November 24, 2021

Subject: Laurel Elementary School HVAC Replacement
San Mateo - Foster City School District
Aedis Project No. 2021005.03
DSA Application #01-119551

ADDENDUM NO. 1

SHEET # AD1-A1.02

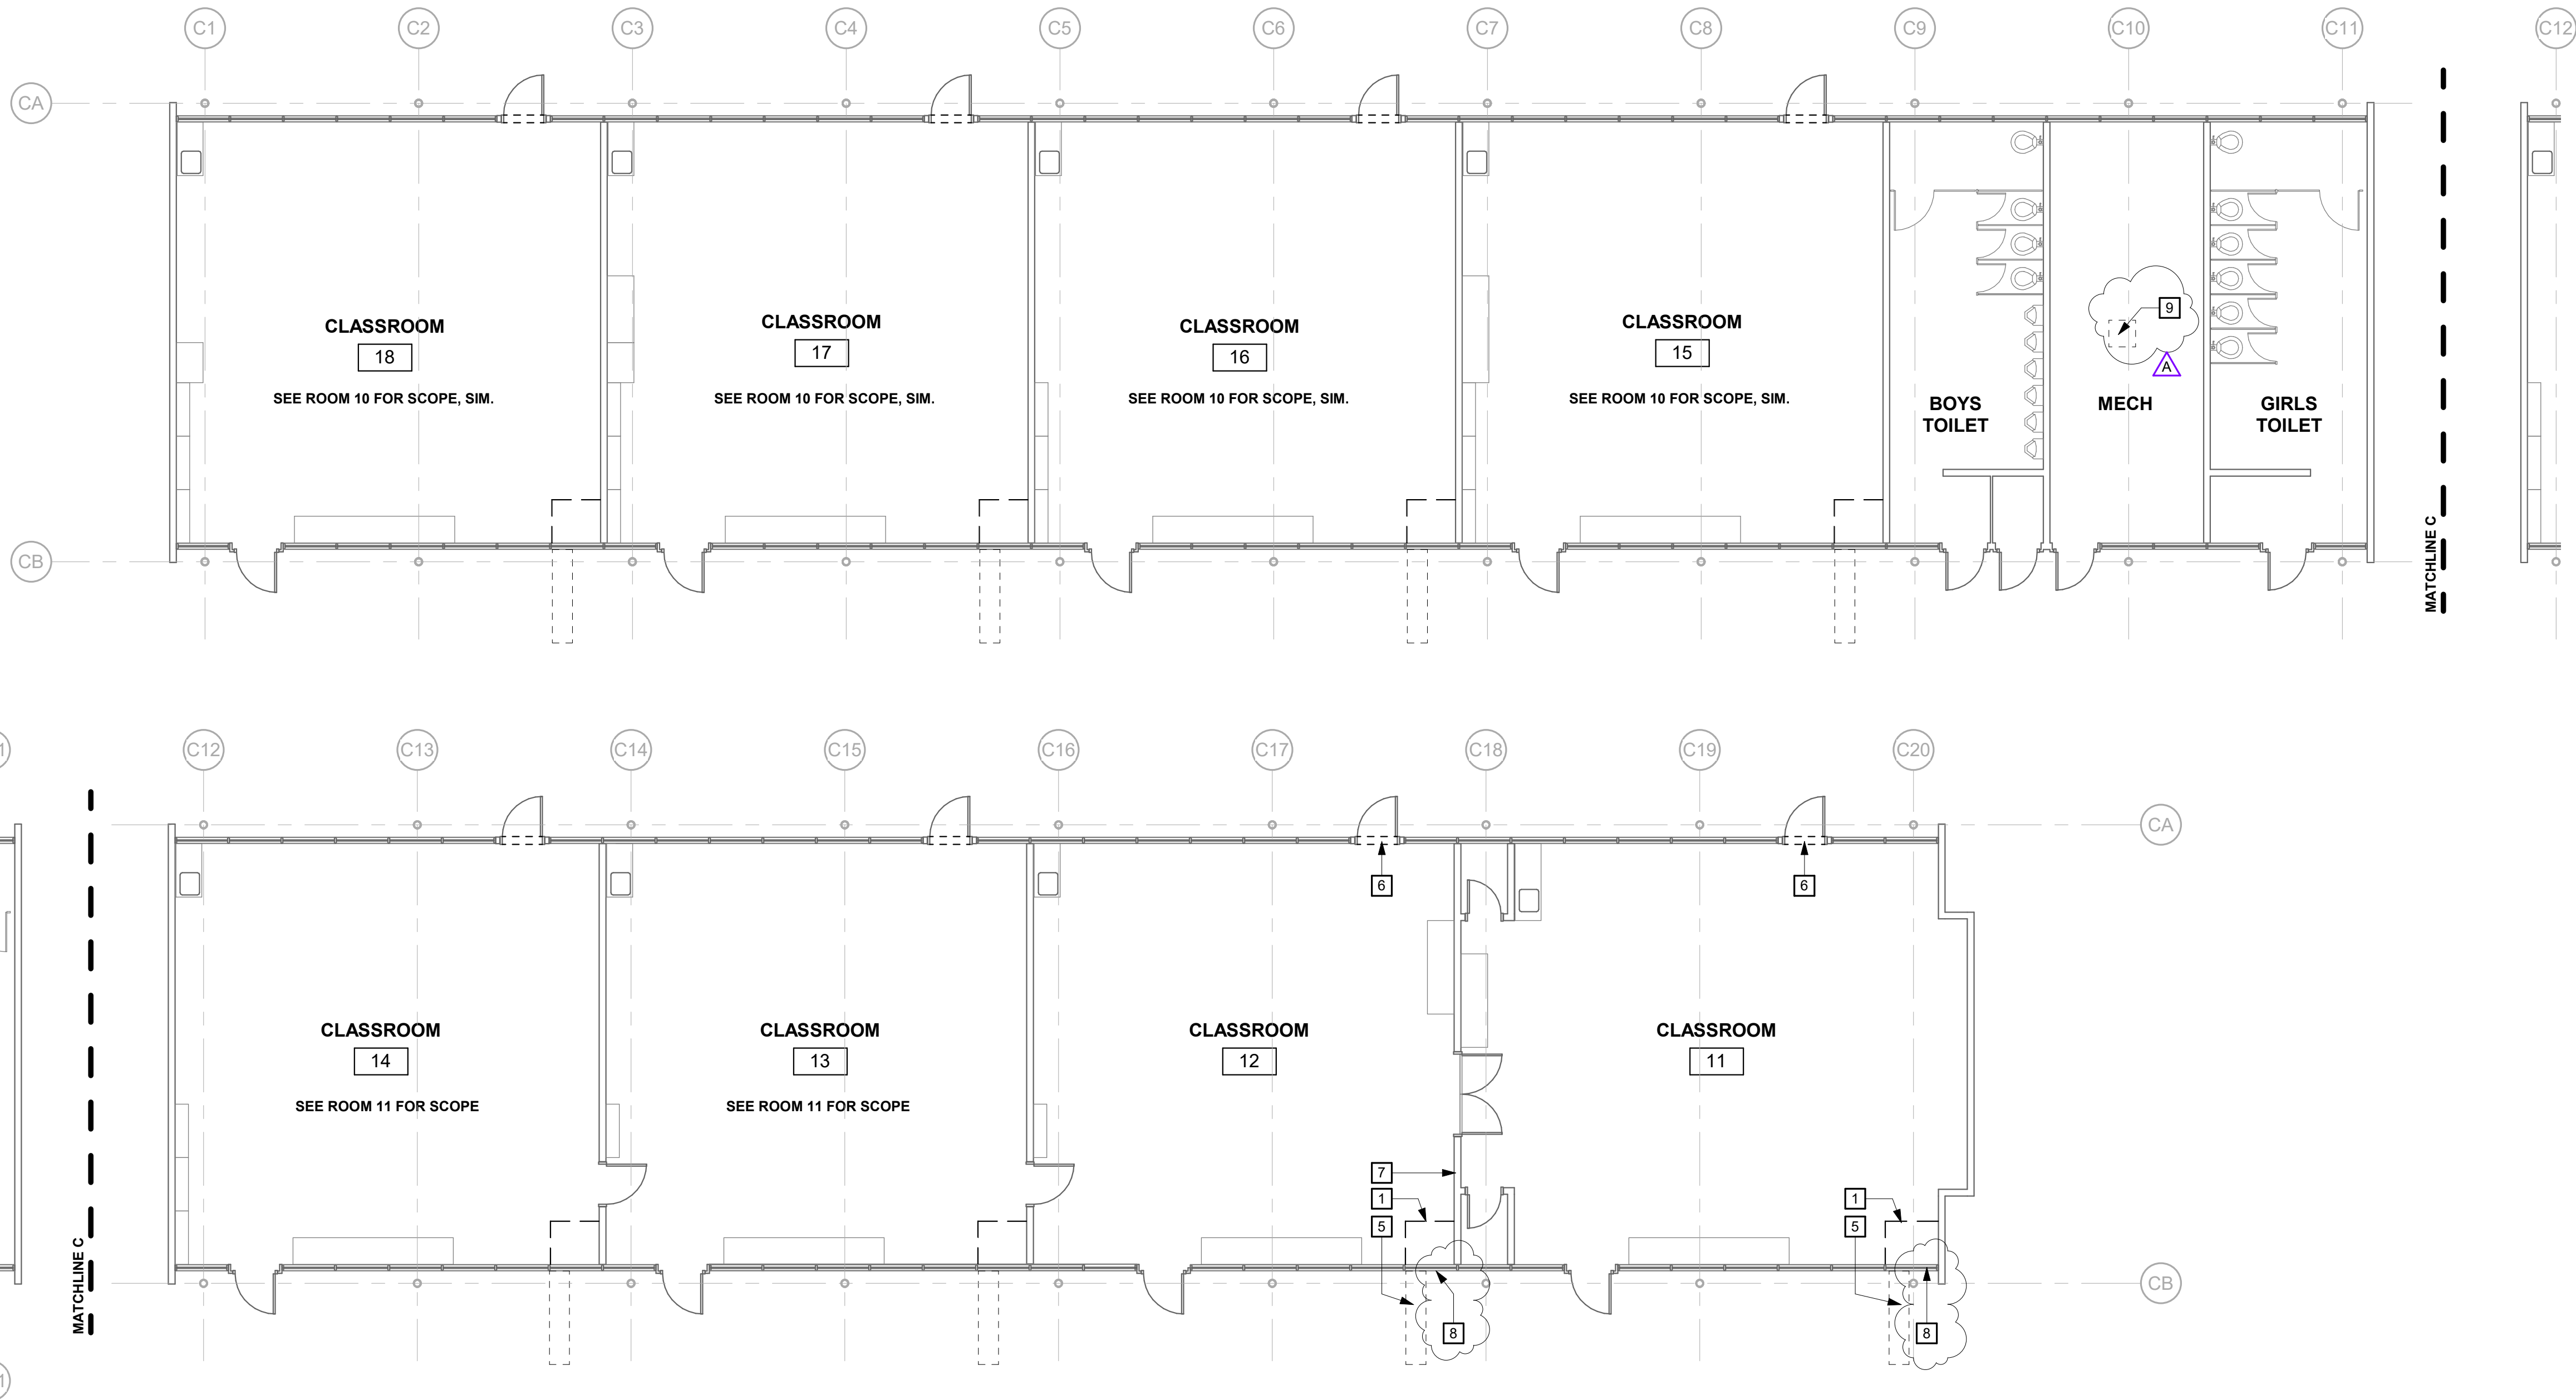
Add: Trench area to New Site Plan 1/A1.02 & Graphic Key per AD1-A1.02

Add: General Sheet Note #G per AD1-A1.02

Add: Site Plan Keynotes #17 to New Site Plan 1/A1.02 per AD1-A1.02

Add: Enlarged plan call outs to 2/A2.02 & 4/A3.02 in New Site Plan 1/A1.02 per AD1-A1.02

SHEET # AD1-

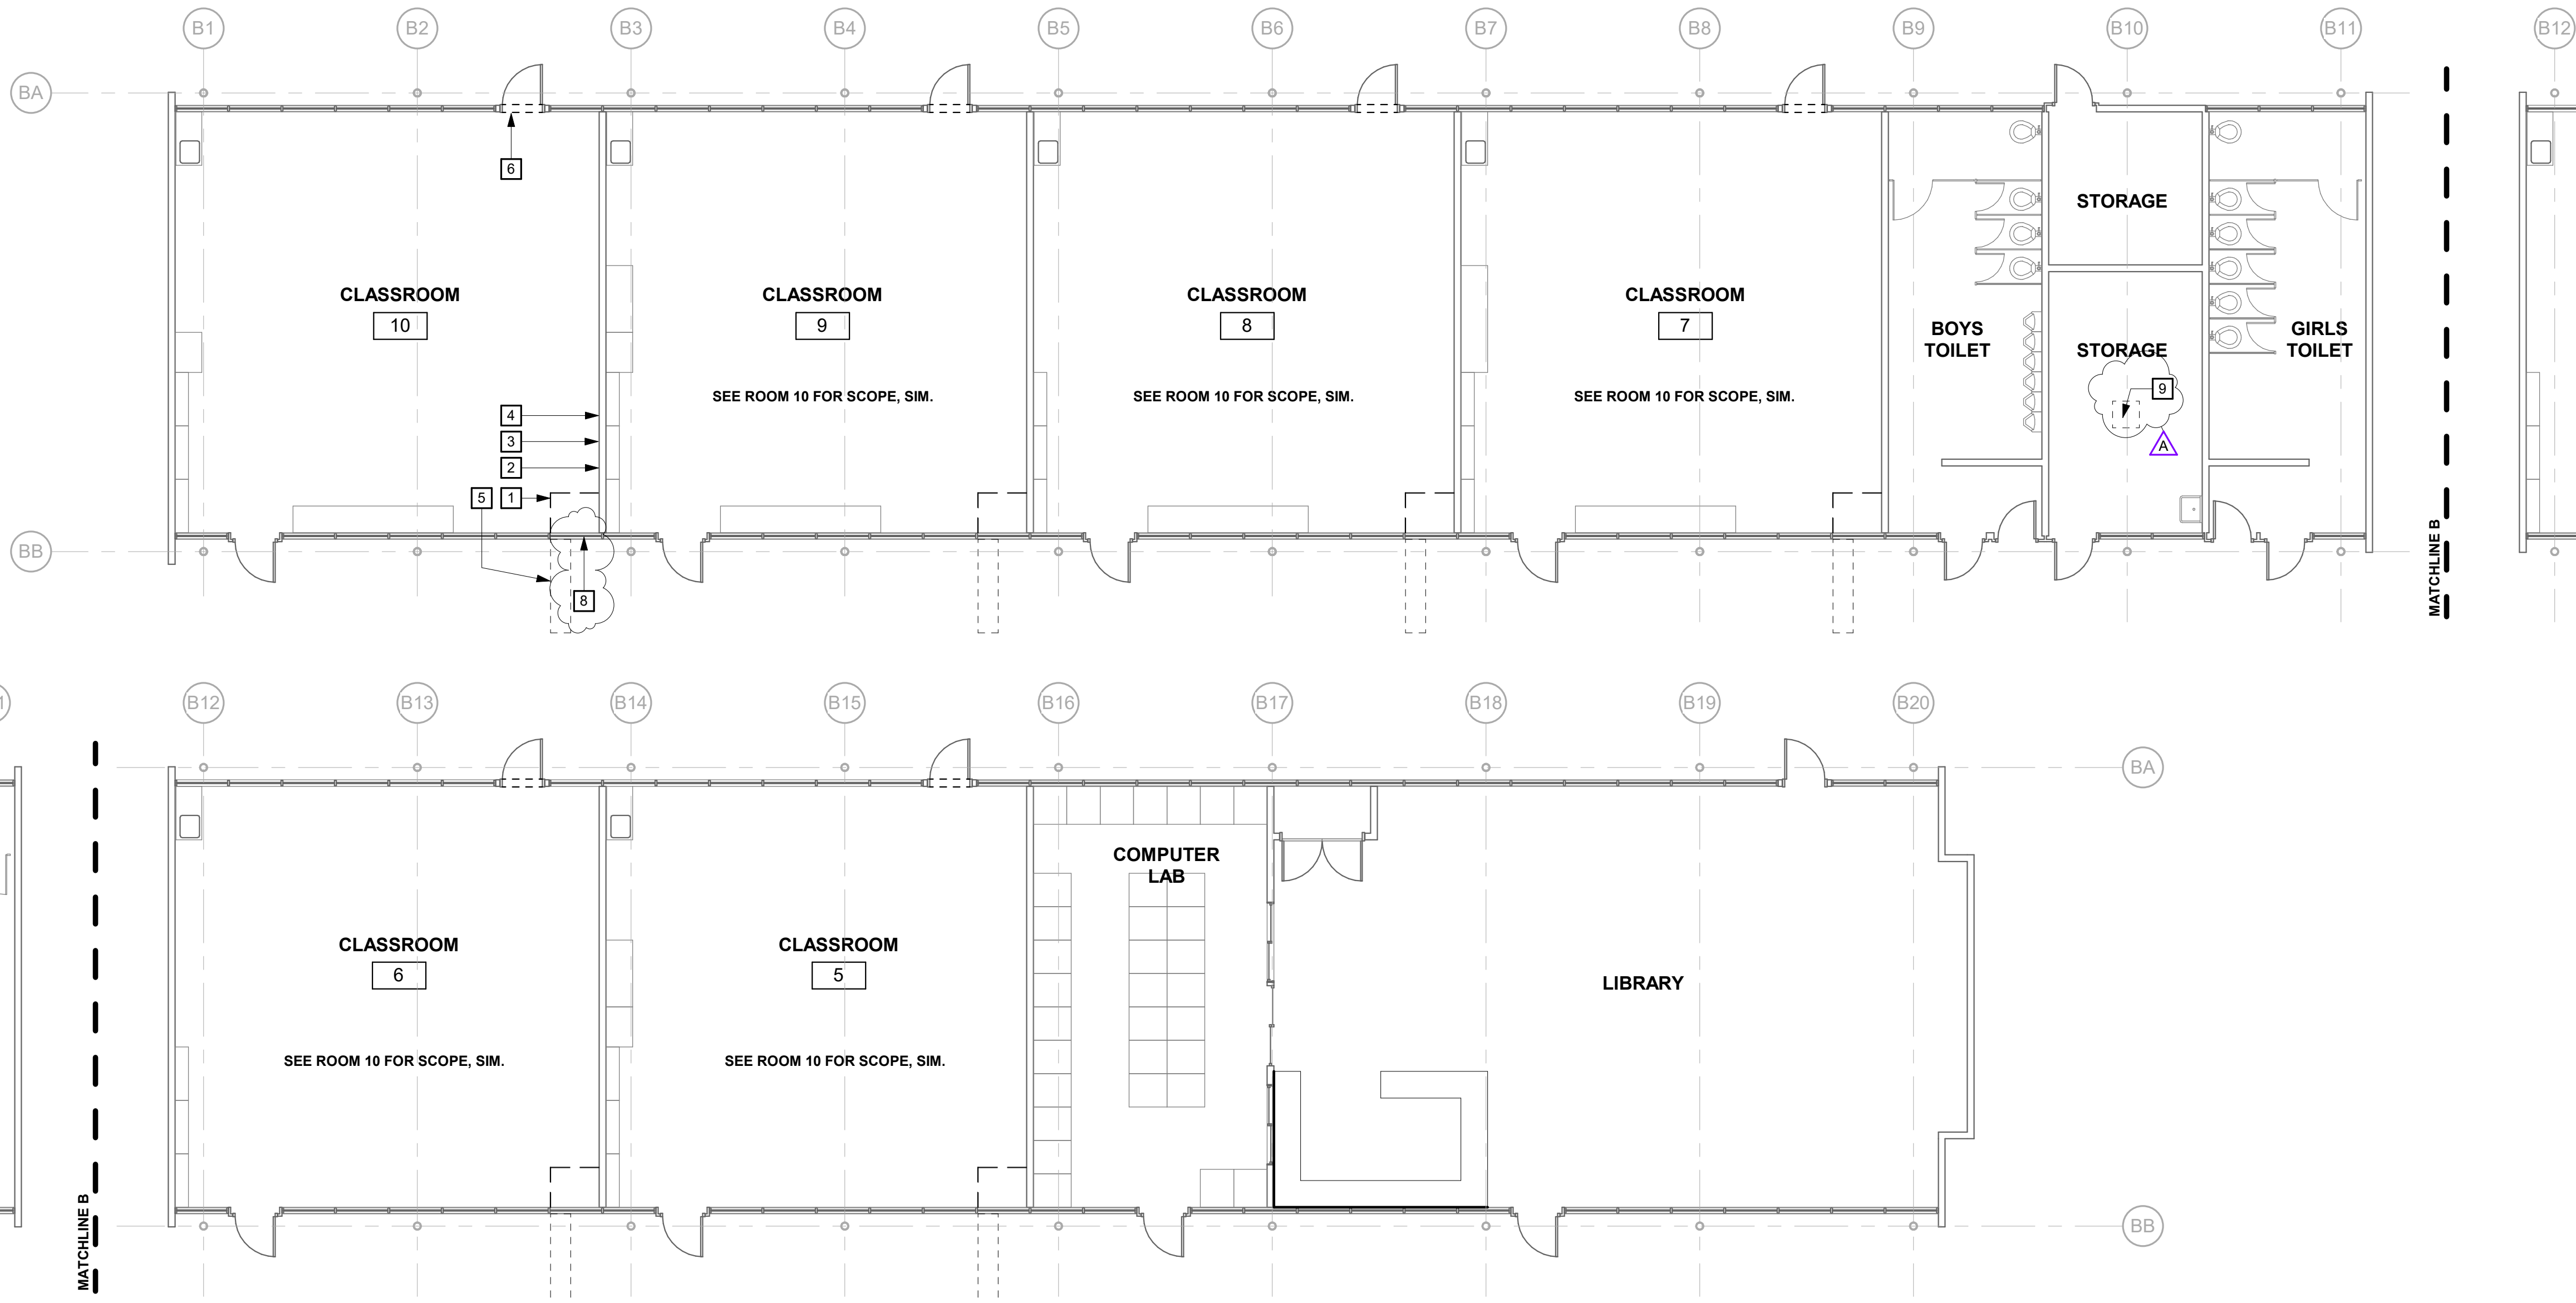
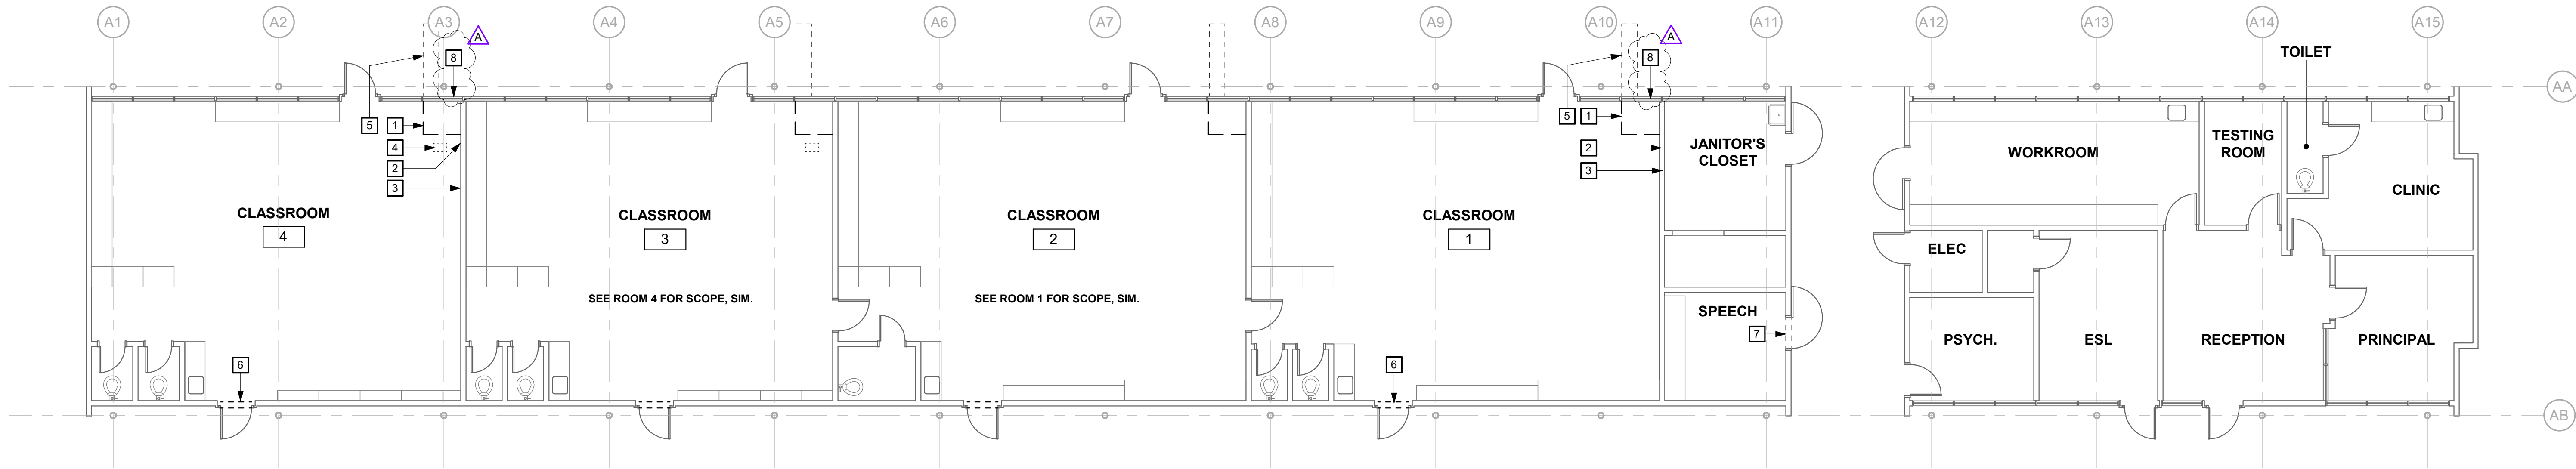
Add: General Sheet Note #J per AD1-A2.01

Revise: Demolition Floor Plan Keynote #1 per AD1-A2.01

Add: Filler panel removal keynote #8 to Demolition Floor Plans 1/A2.01 and 2/A2.01 per AD1-A2.01

Add: Partial ceiling demolition keynote #9 to Demolition Floor Plans 1/A2.01 and 2/A2.01 per AD1-A2.01
